VPCH Office Expansion  
155 Queen St N  
Hamilton, ON L8R 2V6

**Construction Tender**  
**ARCHITECTURAL ADDENDUM**  
**No. 03**

Friday, October 06, 2023

1 ELEVATION - SOUTH EXTERIOR

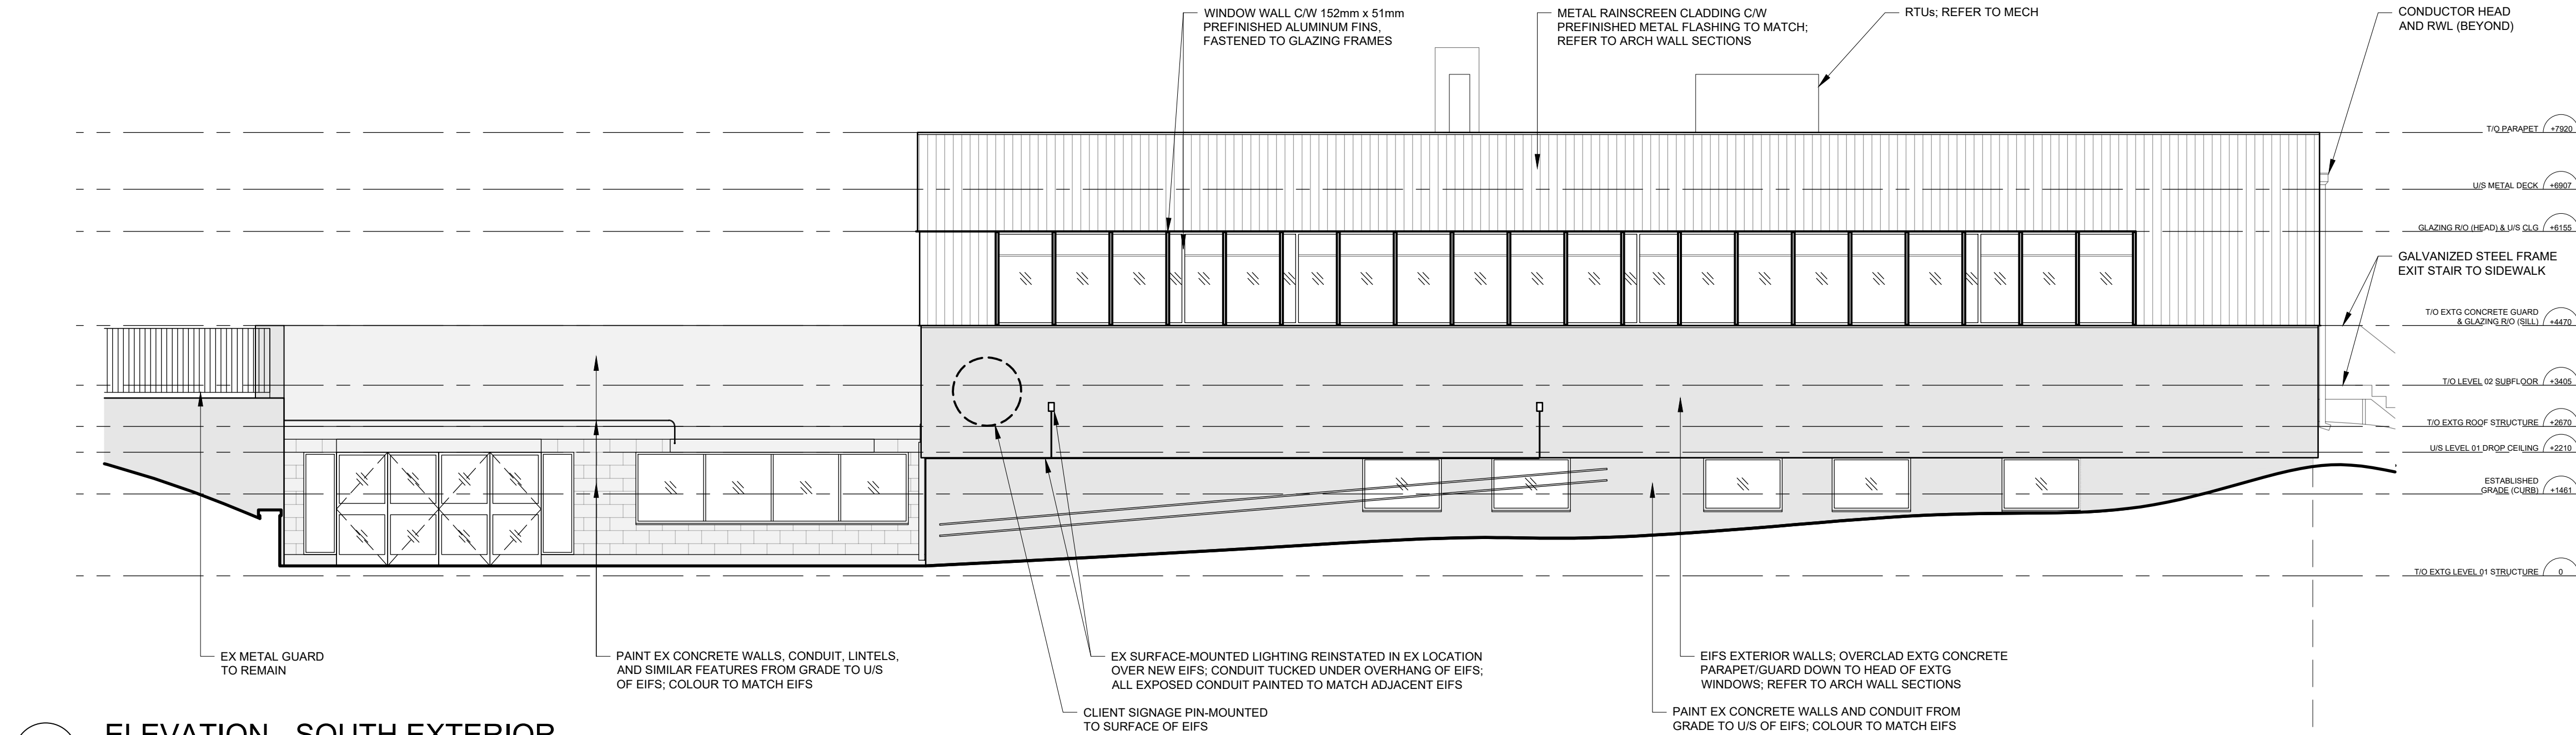
On drawing A02.02 detail 1 (Elevation - South Exterior) notes client signage pin-mounted to surface of EIFS - please advise if this signage is to be carried under GC scope of work. If yes, please provide specification.

**Response:** GC to carry exterior signage under GC scope. 10mm thick metal pinmounted round sign of VPCH logo shall be installed at this location.

1 PLAN - NEW UNIVERSAL WASHROOM

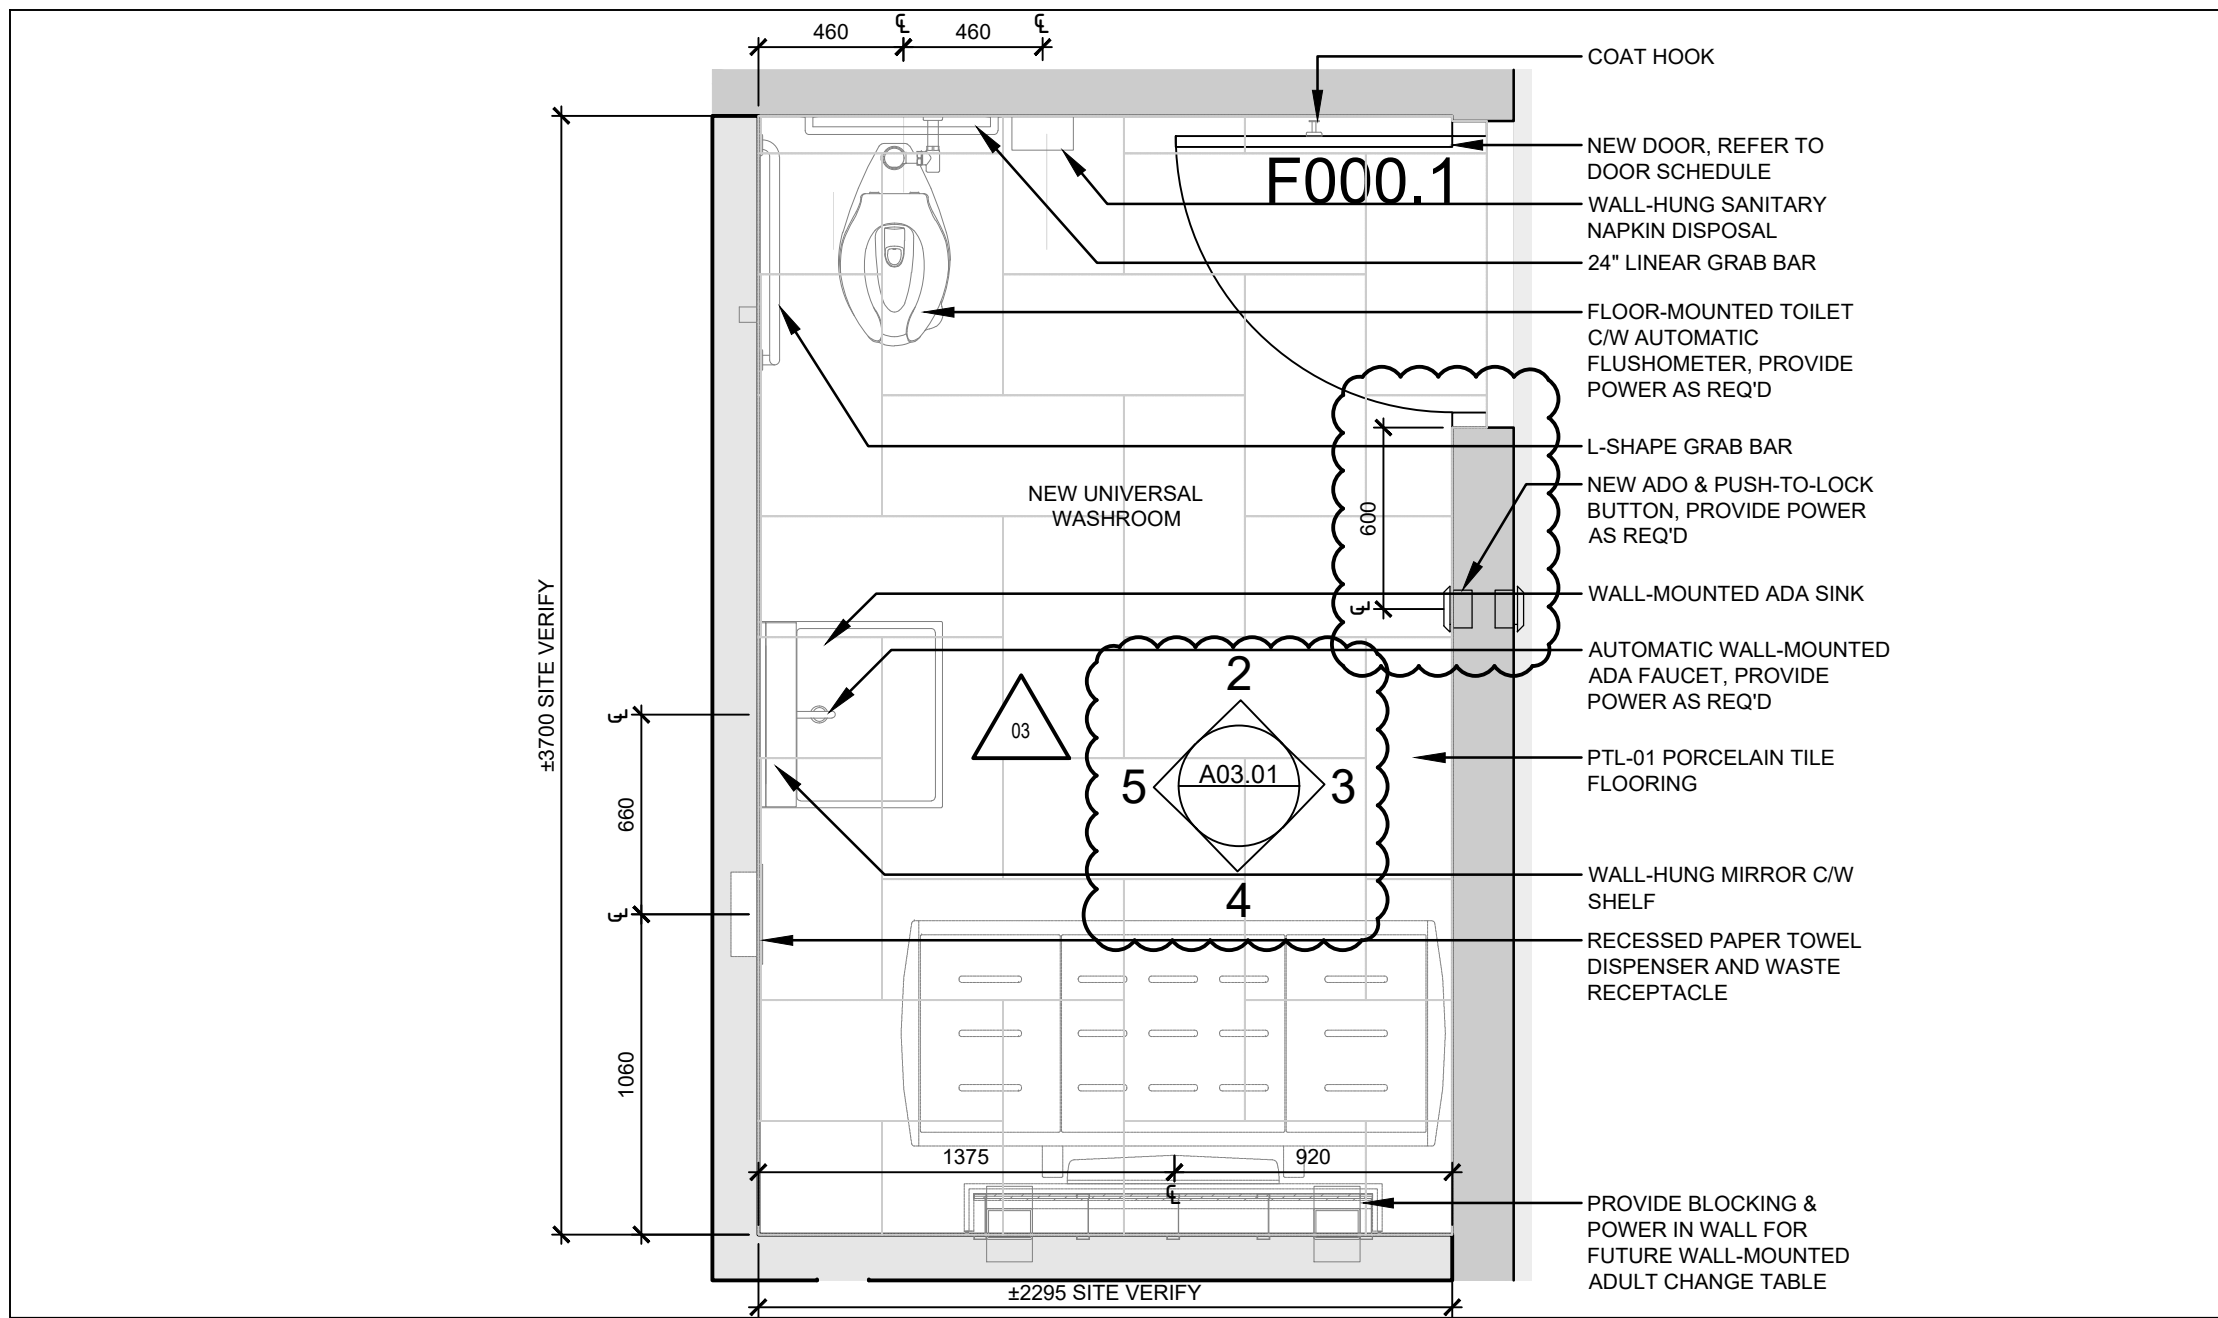
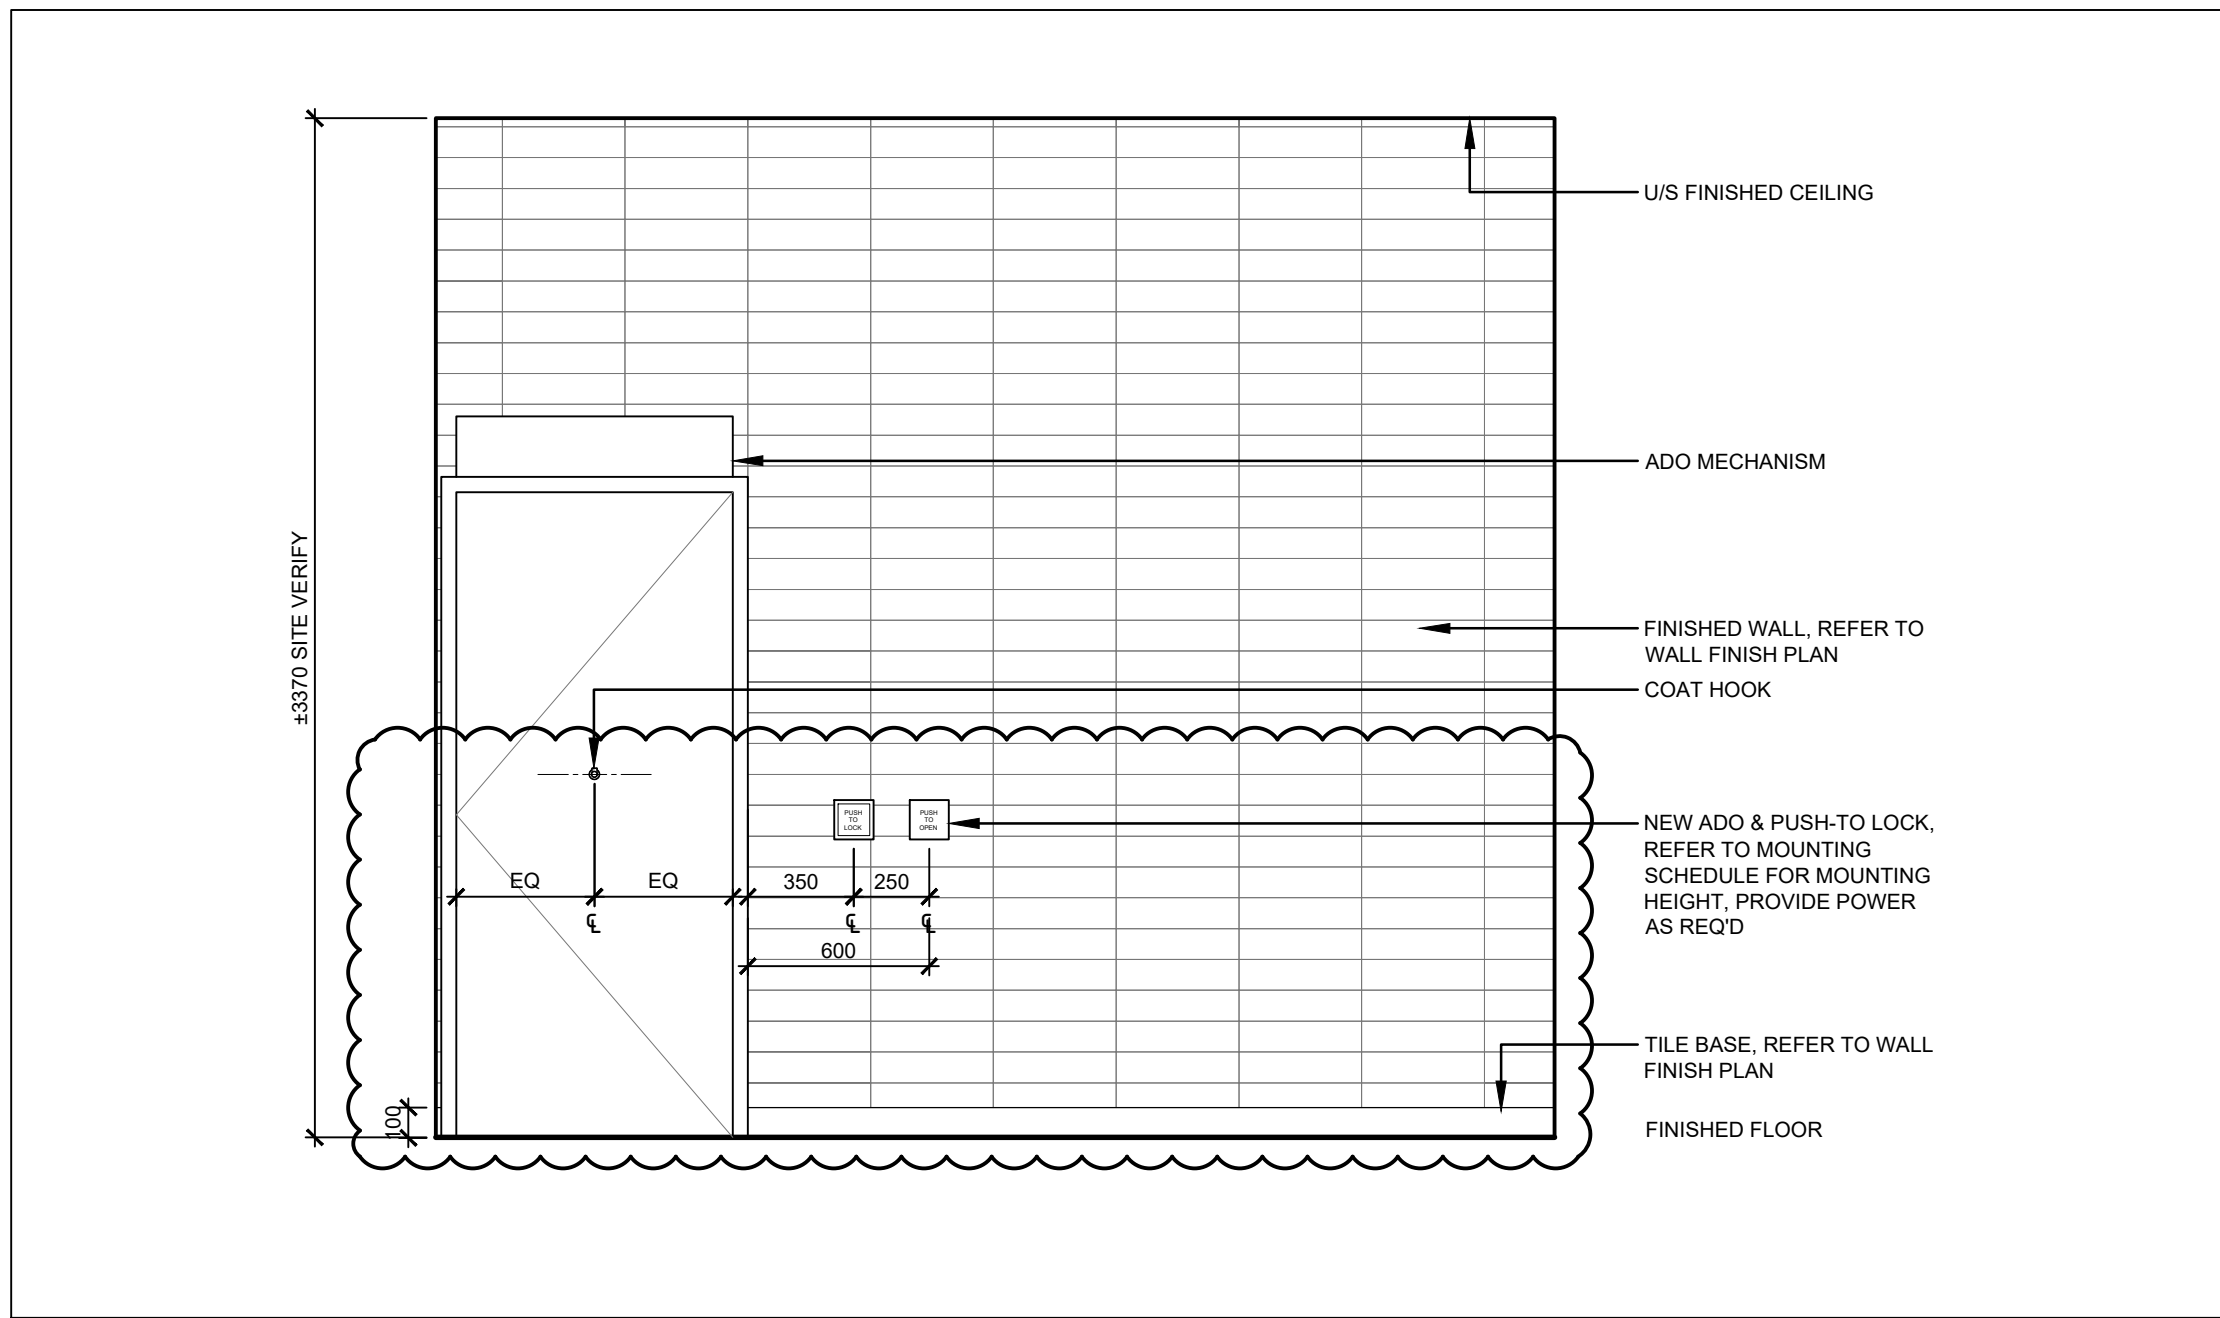
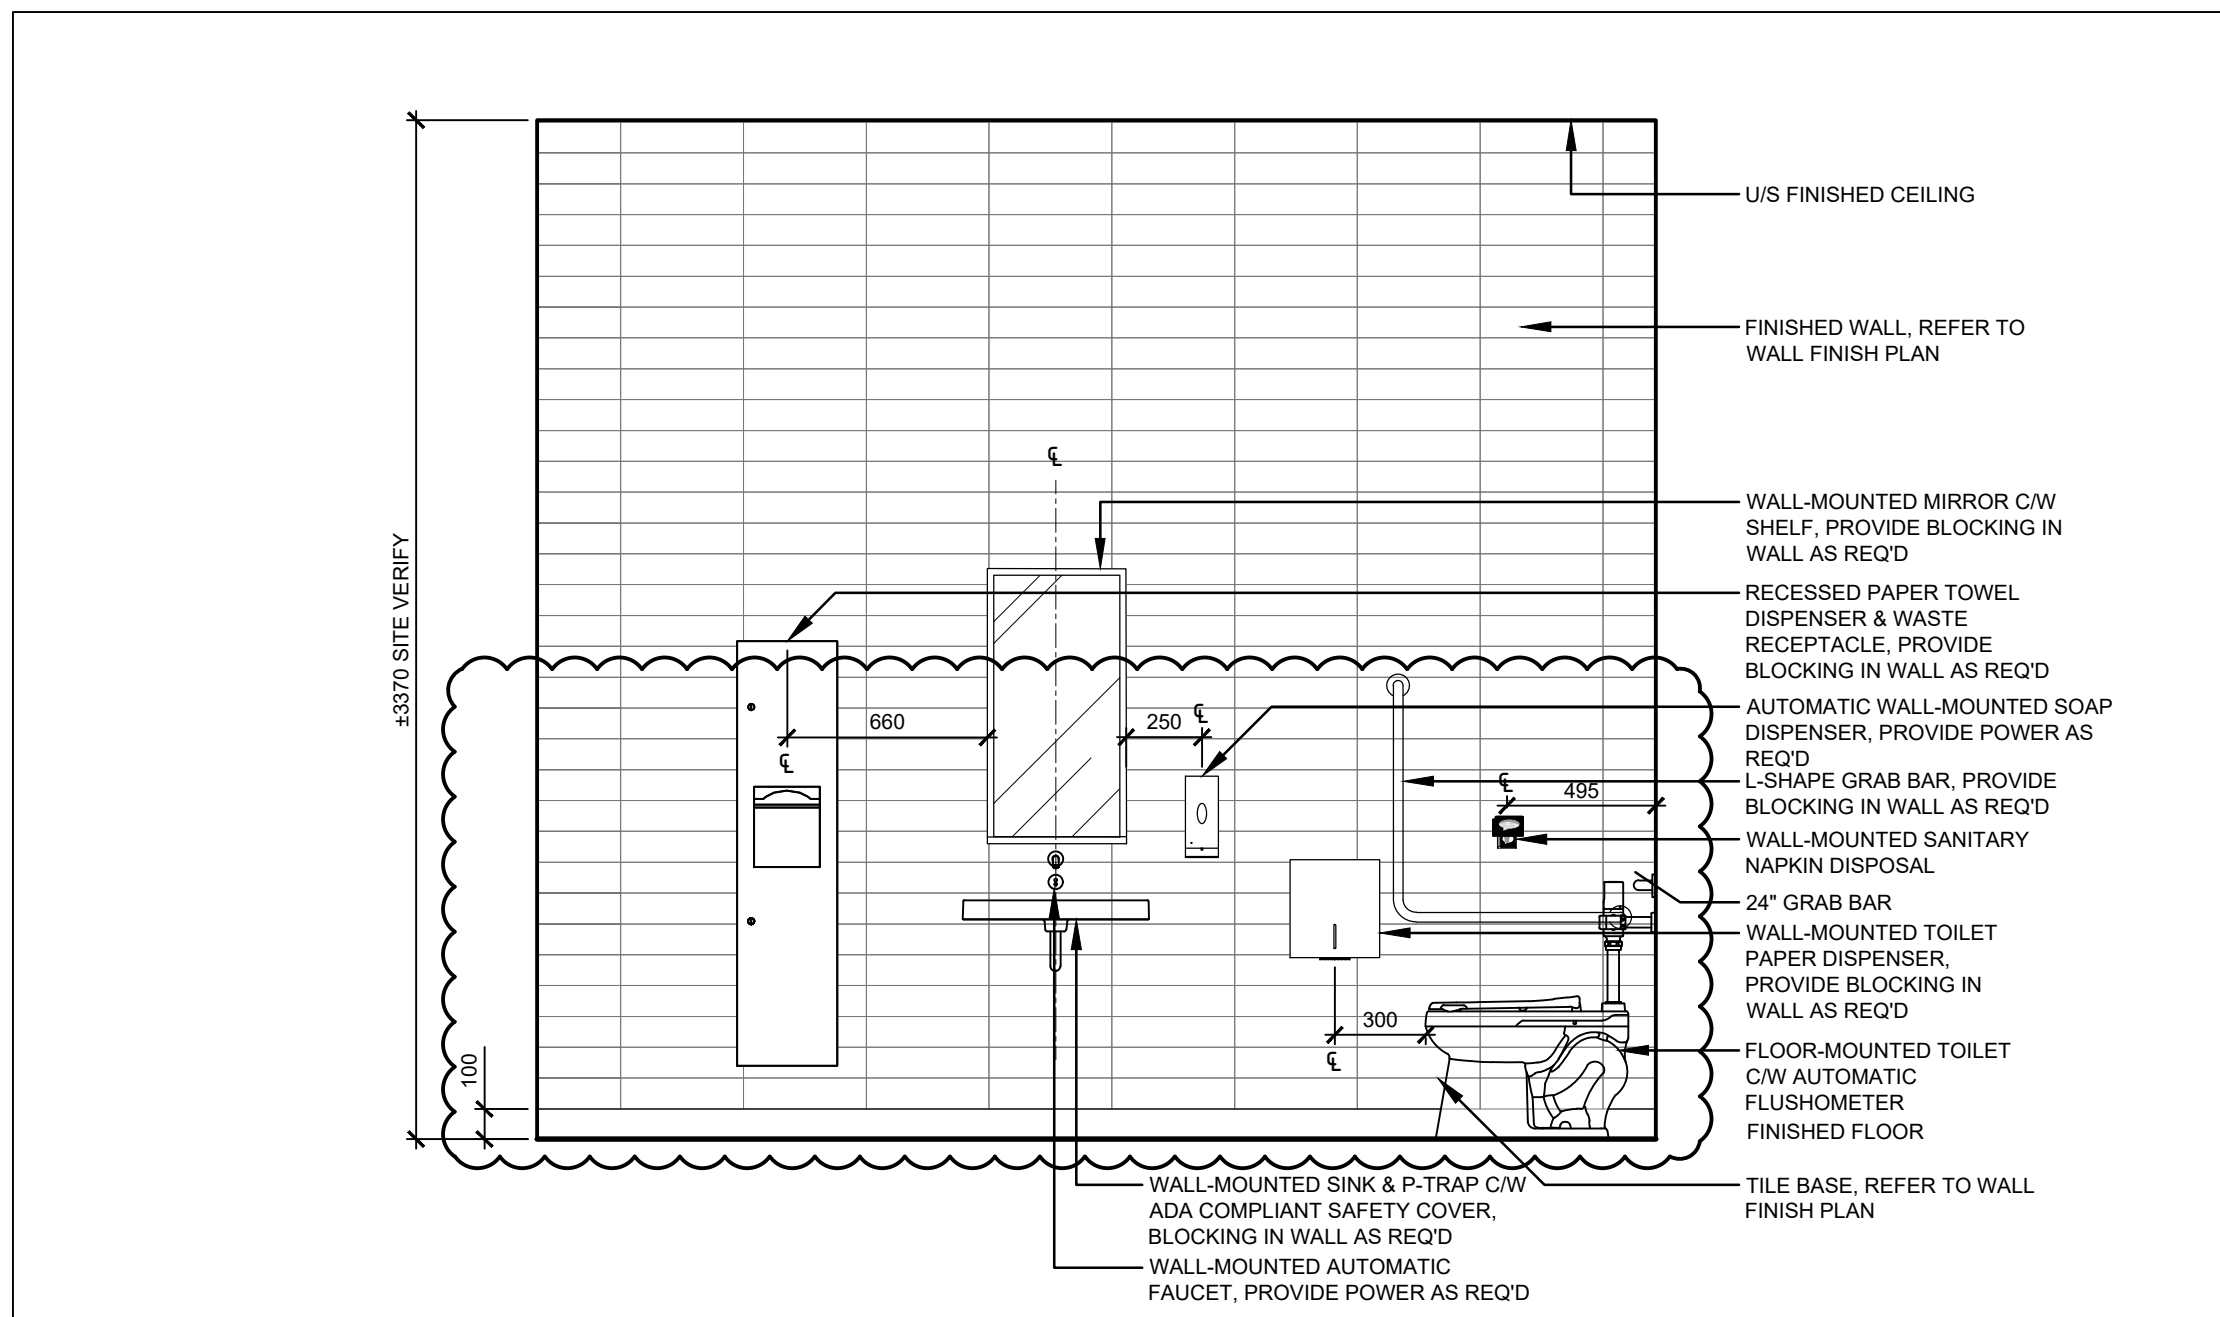
On drawing A03.01 the tiles on the lower half of walls in new universal washroom indicate to see drawing A07.00 for tile size. But A07.00 is not existed. and by scale the tile is 80cm x120cm. - When A07.00 as Wall Finish Plan is not existed; there are A01.11 & A01.12 are Wall Finish Plan, but doesn't have wall tile information - in fact, some other place refer to Architecture drawing A10.xx, and not drawings with number bigger A05.xx are existed

**Response:** Please refer to new naming conventions on drawings in Addendum 3.
